TO: PCS Group Inc., Applicant
FROM: Julia Duncan, Associate Planner
DATE: January 24, 2022
SUBJECT: SUB21-073; Compark Village South Tract G Sketch Plan
SUB21-074; Compark Village South Tract G Preliminary Plan
Review Comments 01

COMPARK VILLAGE SOUTH SKETCH PLAN

Compark Village South
Tract A Preliminary
Plan

COMPARK VILLAGE SOUTH
LANDSCAPE PLANS AND
MASTER STREET TREE PLANS

SHEET TITLE
PRELIMINARY PLAN COVER

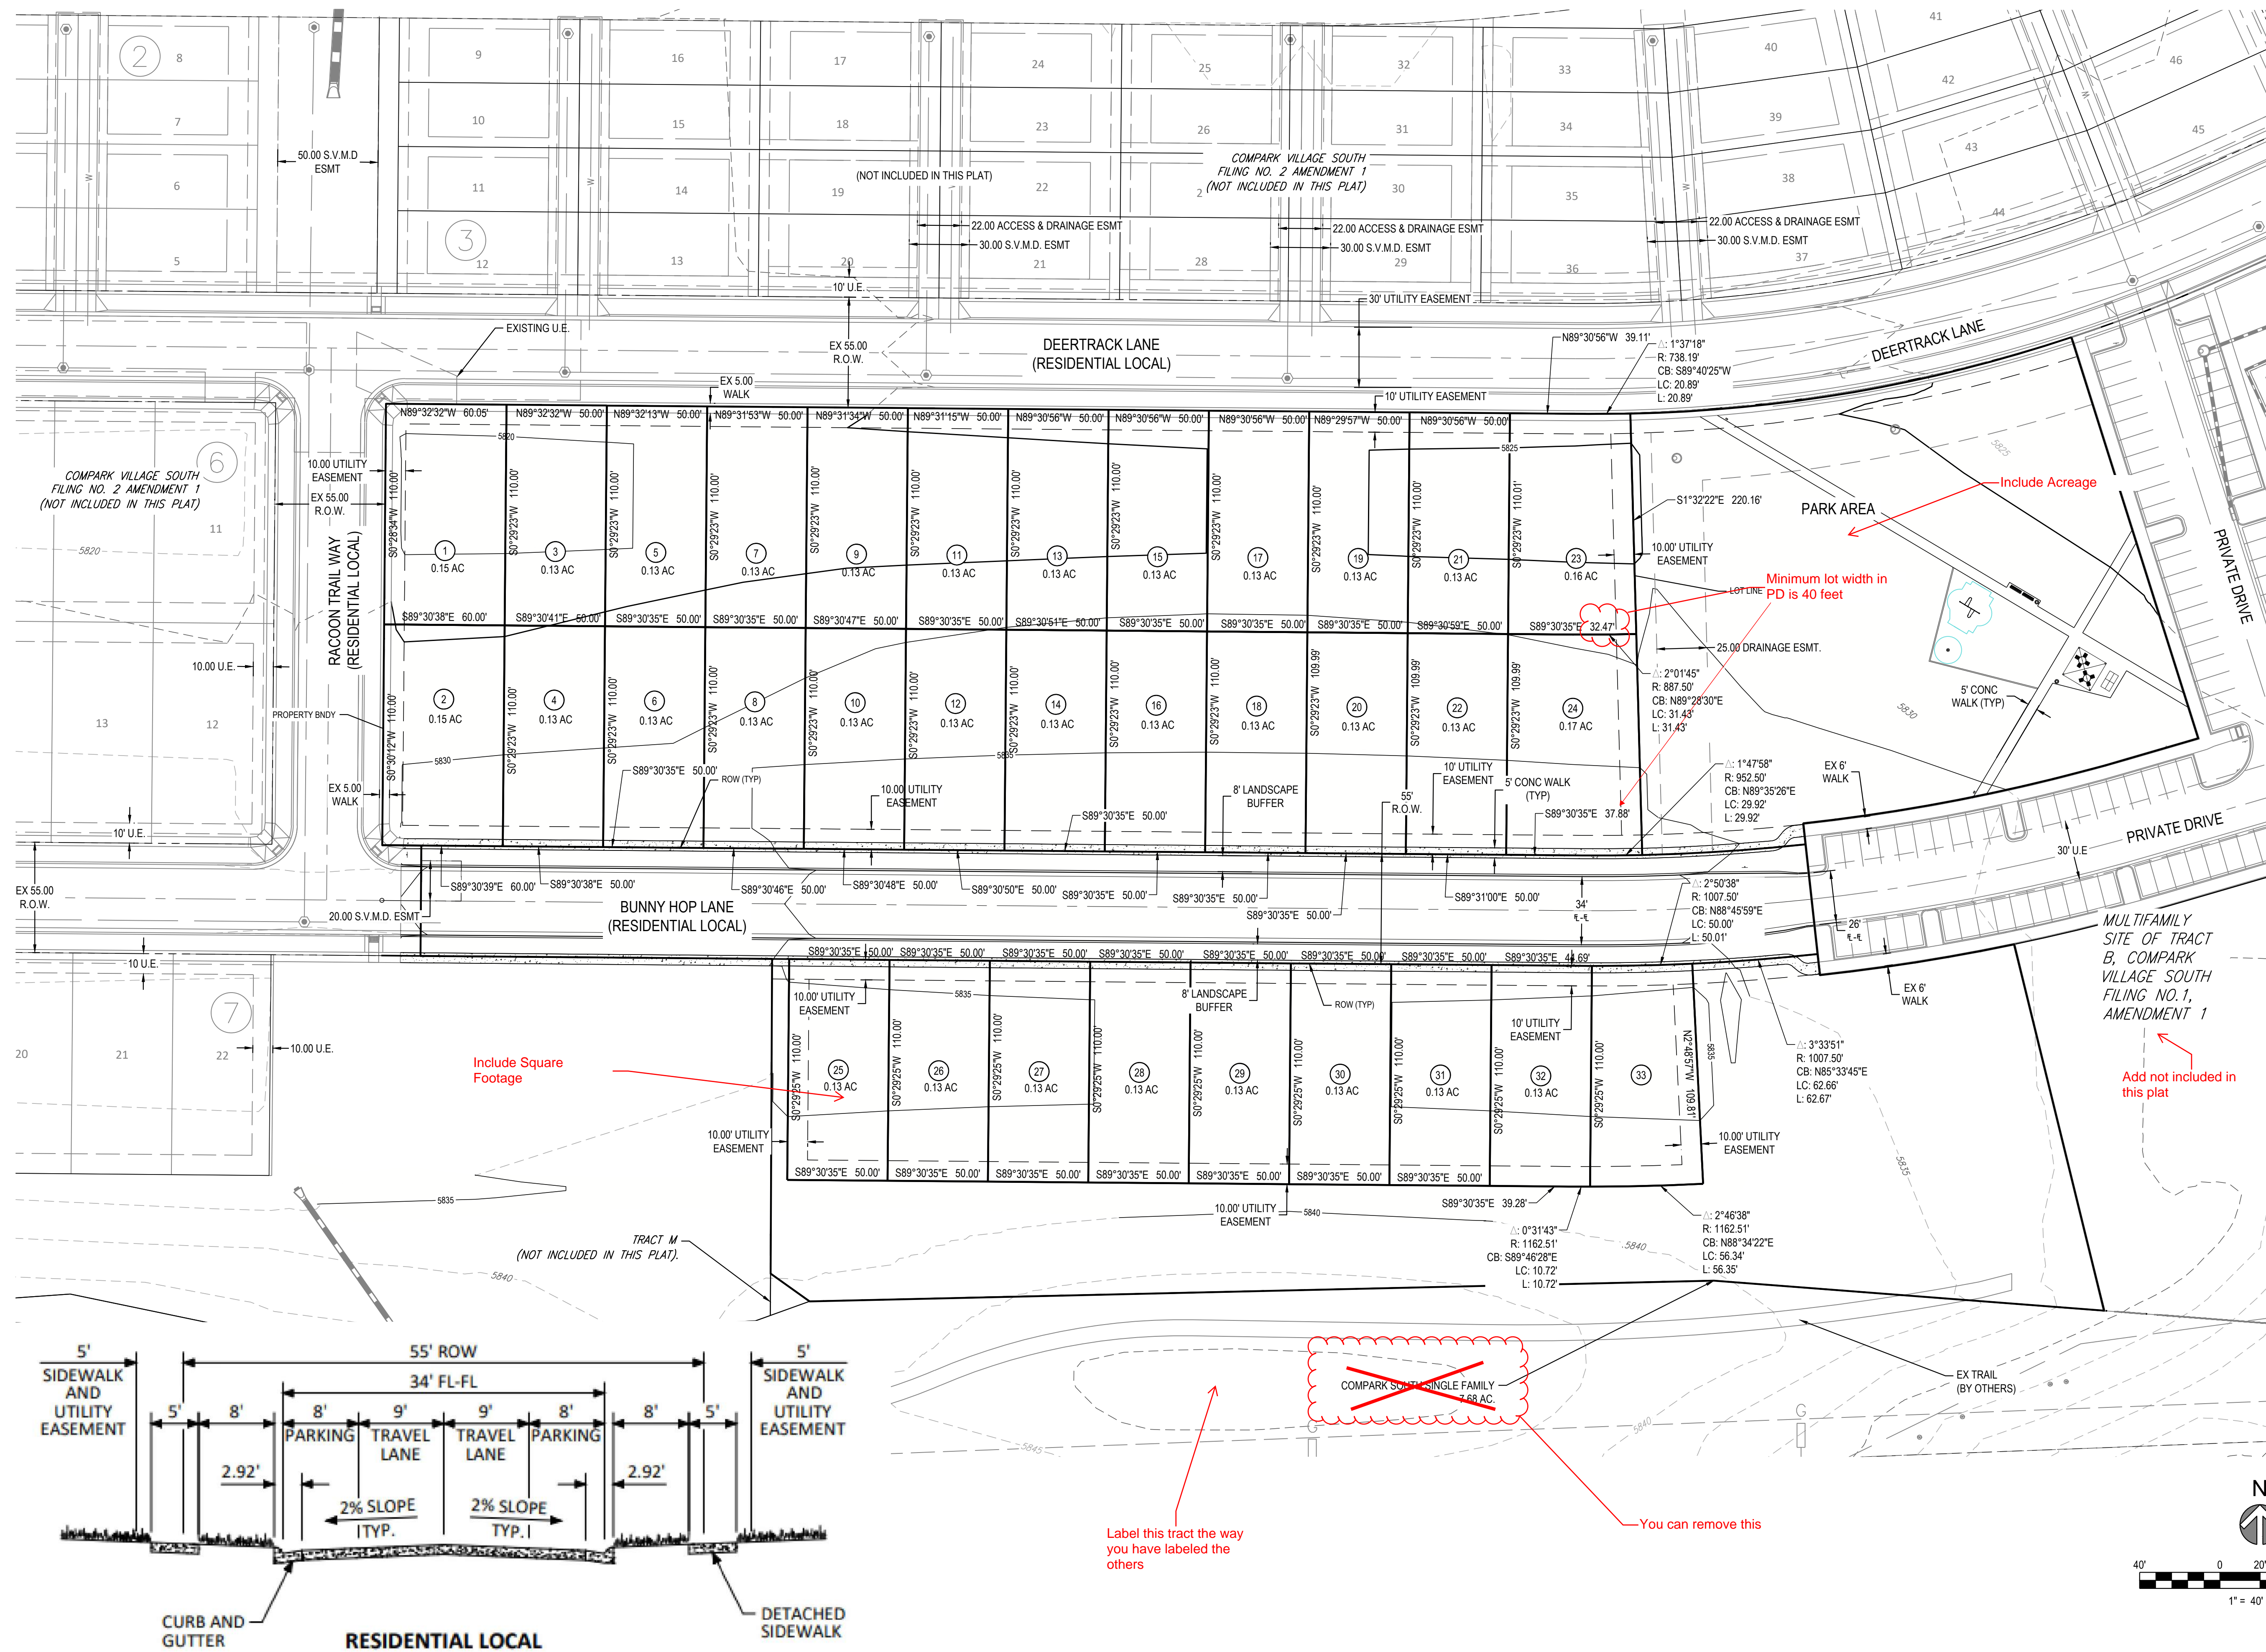
Include Legal
Description

Include acreage,
number of lots, and
number of tracts

Include Plan Area from
PD

Need to include Land
Use Summary Tables
like the below
examples-please
ignore redlines and
just reference charts
for example

Sheet Name
COVER SHEET
Sheet Number

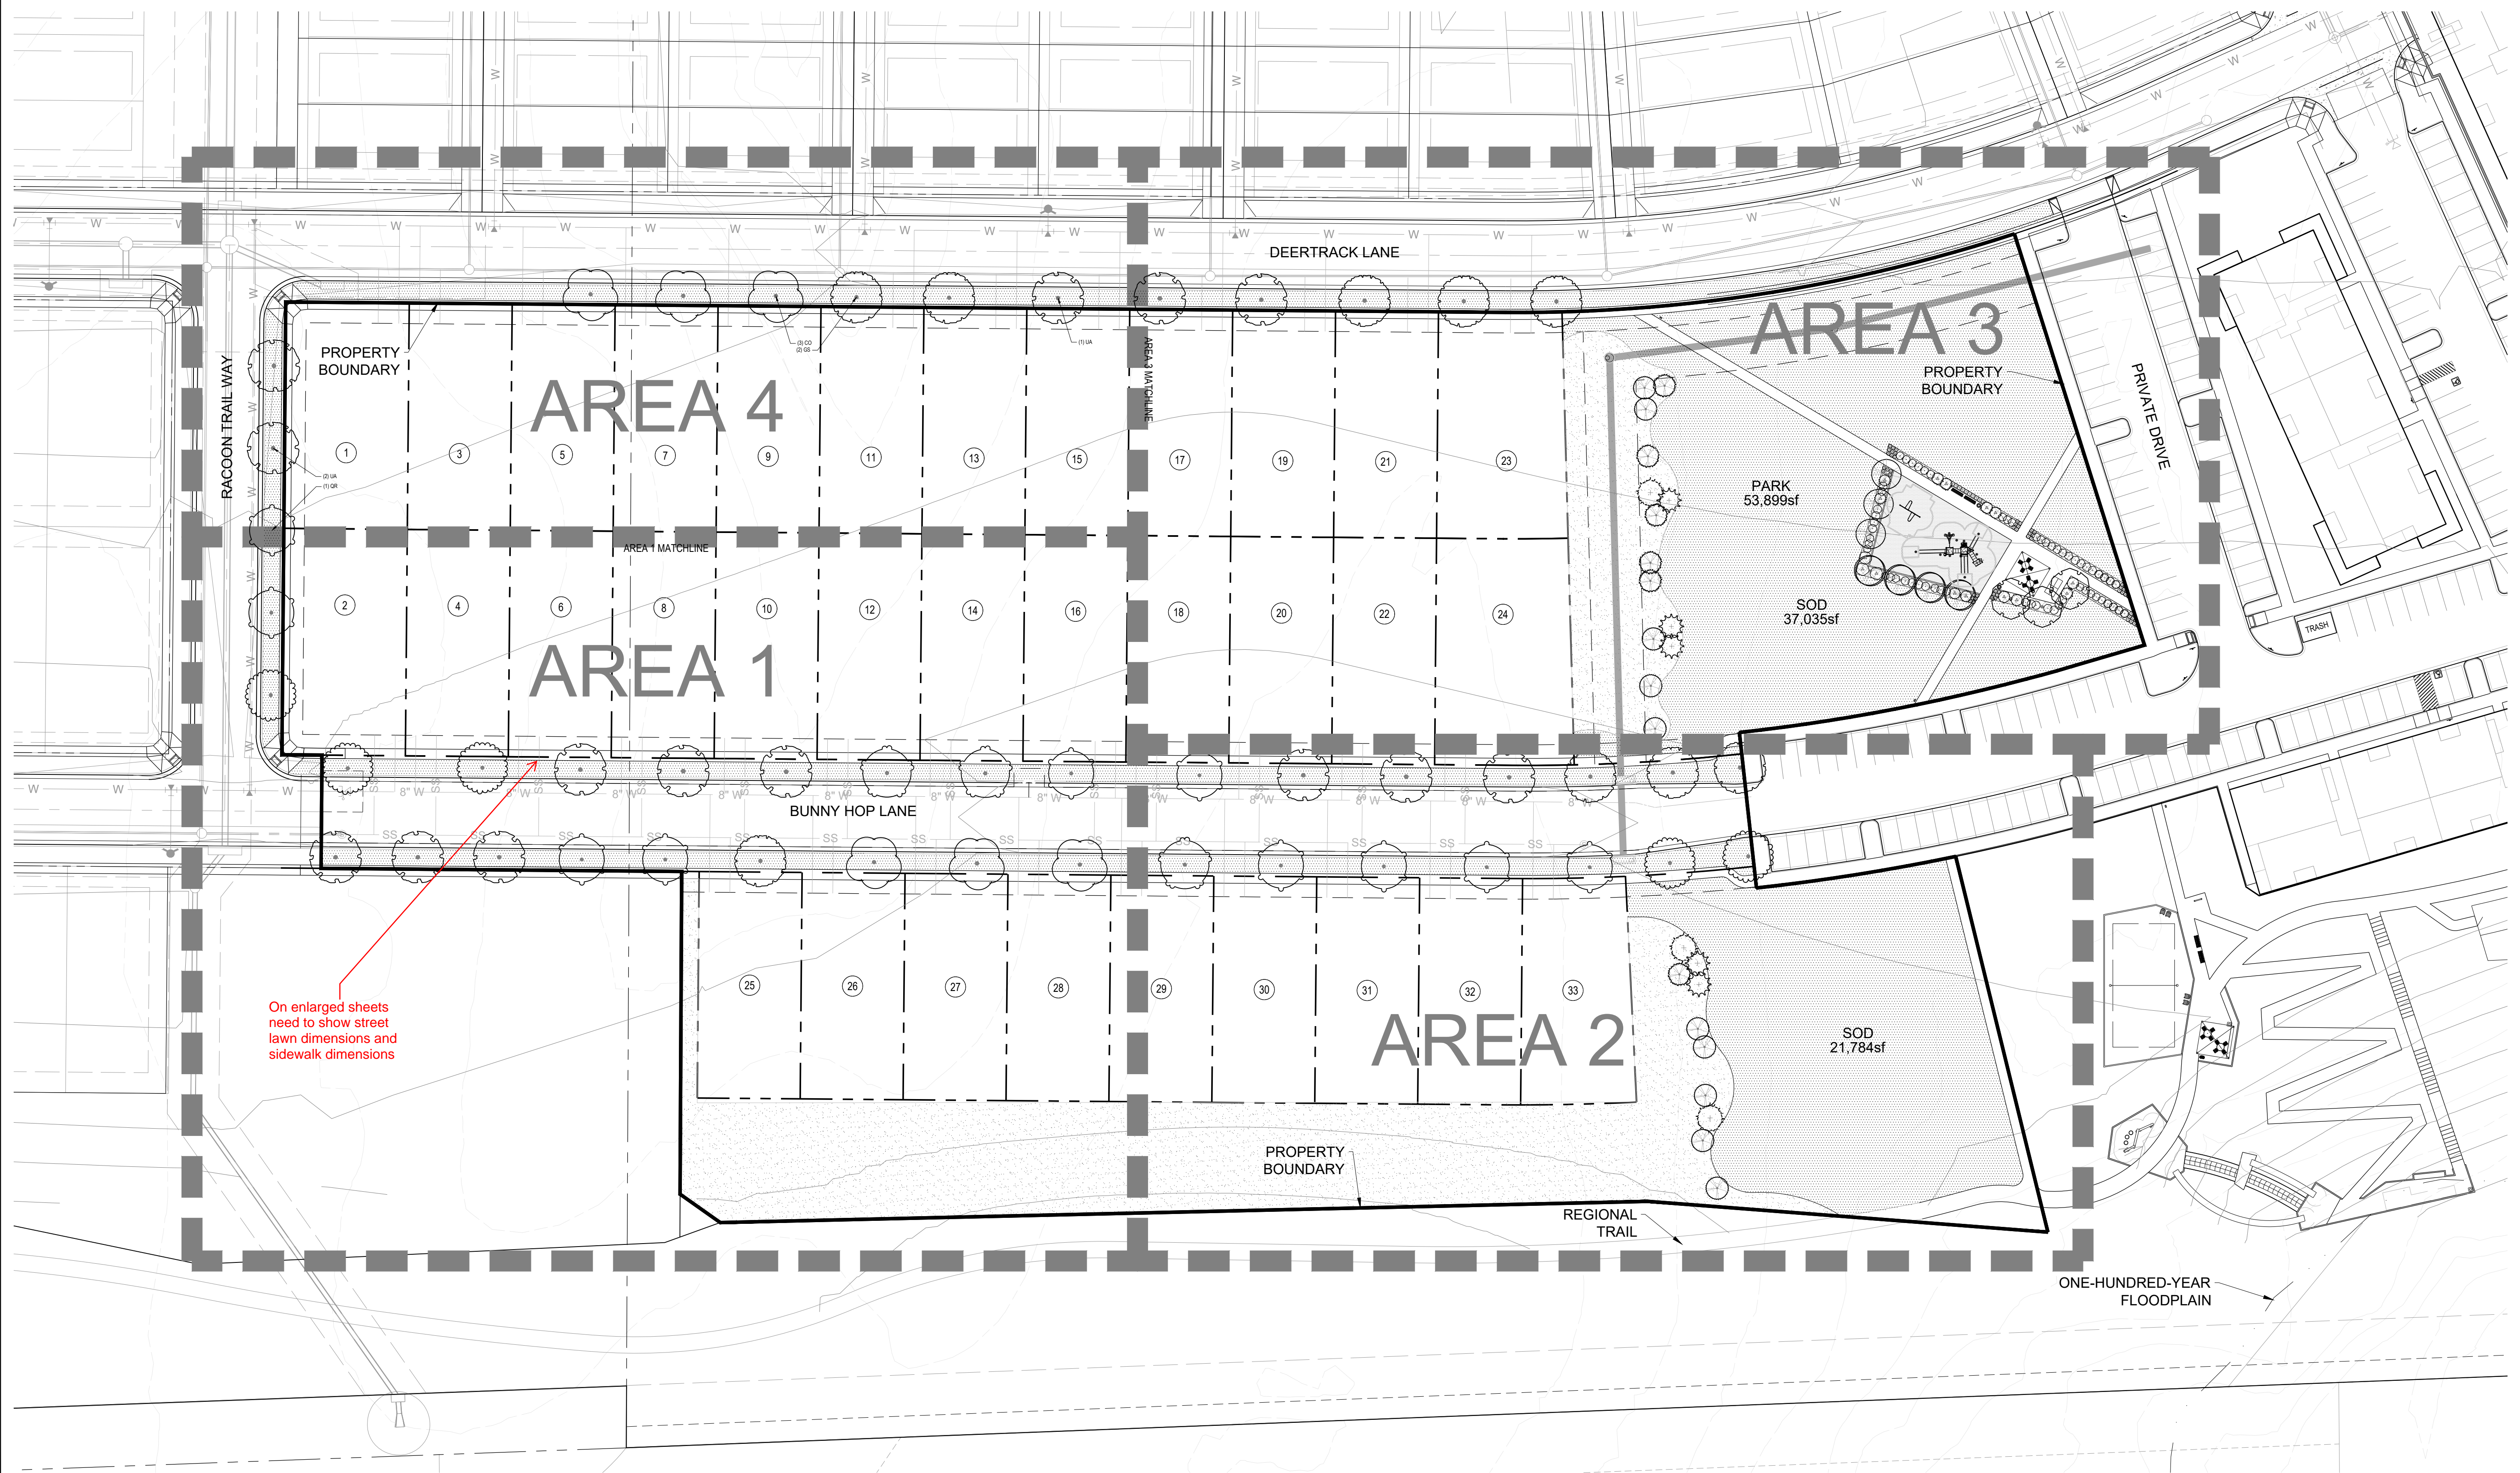
Need to include an irrigation plan

1 MASTER LANDSCAPE PLAN

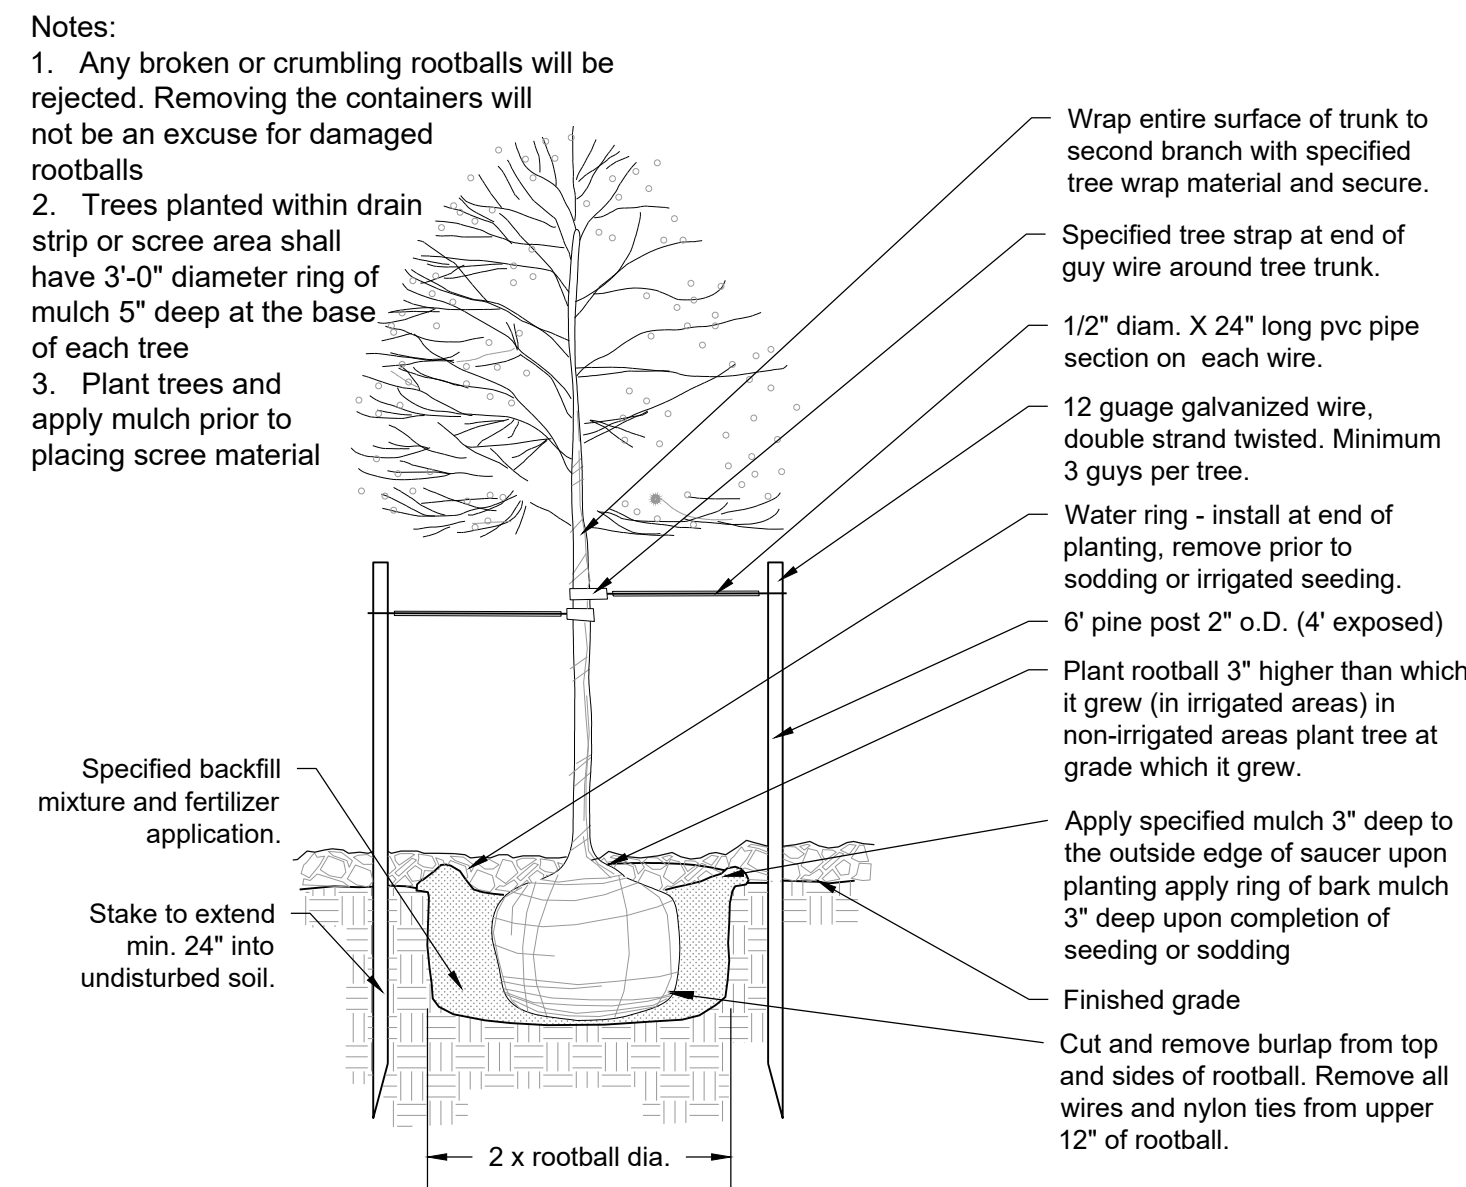
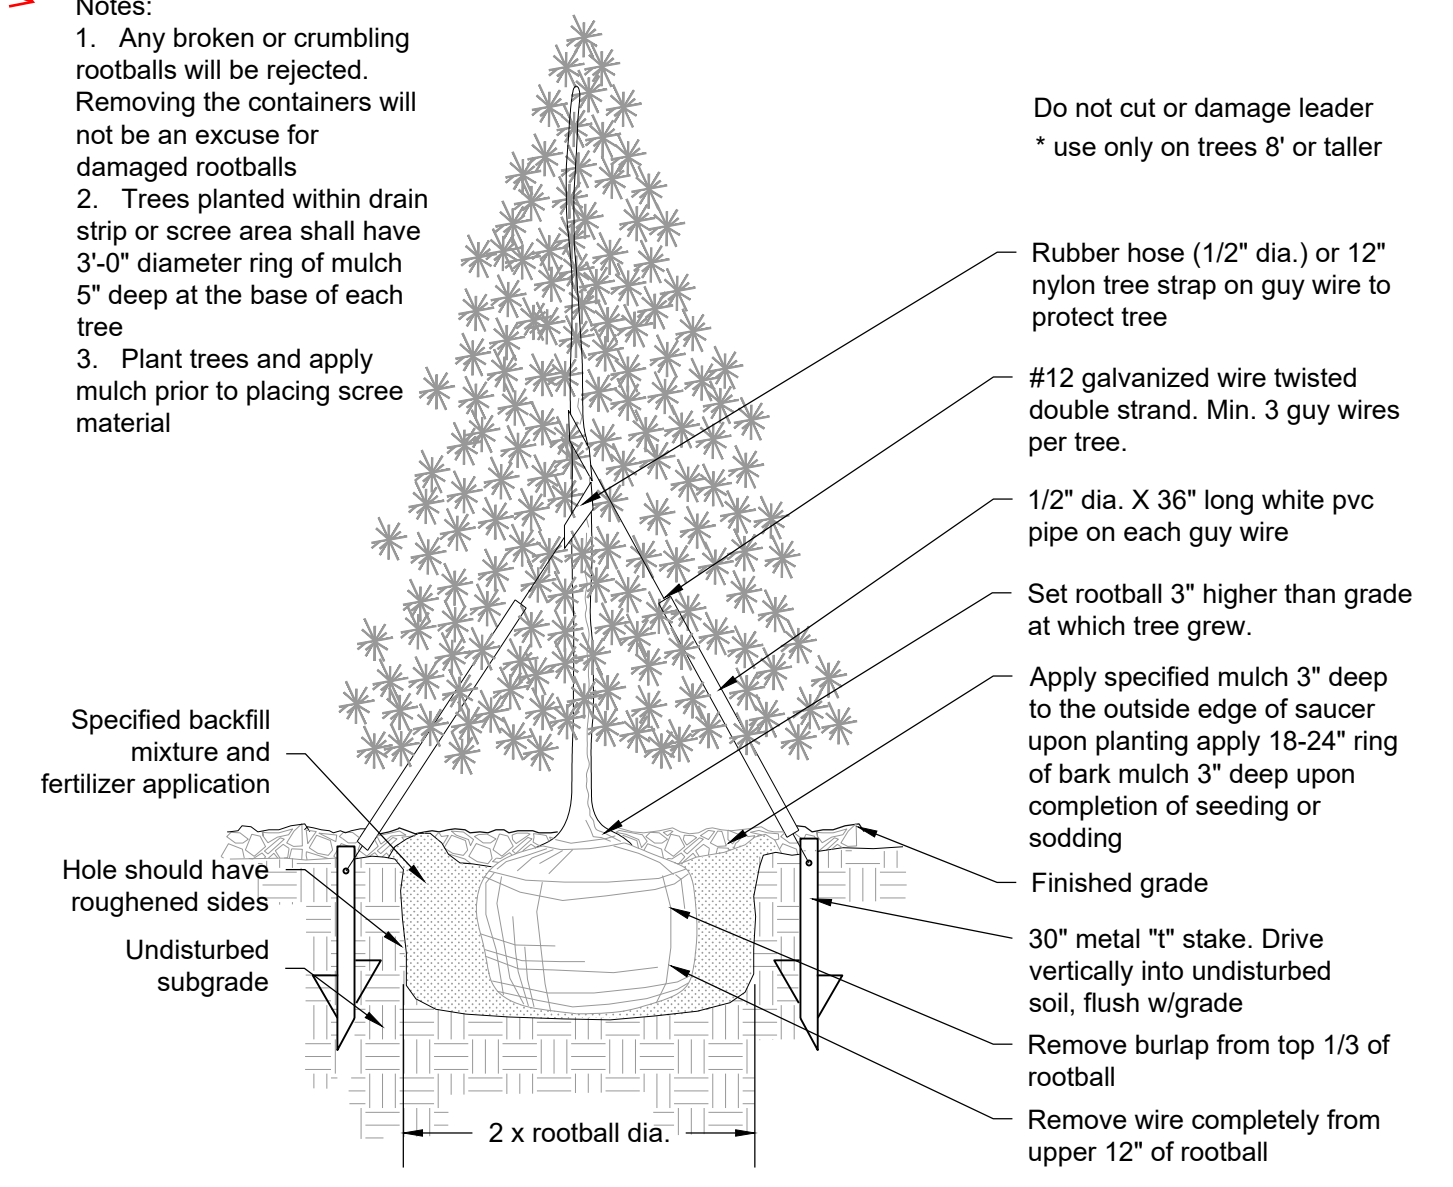
On enlarged sheets
need to show street
lawn dimensions and
sidewalk dimensions
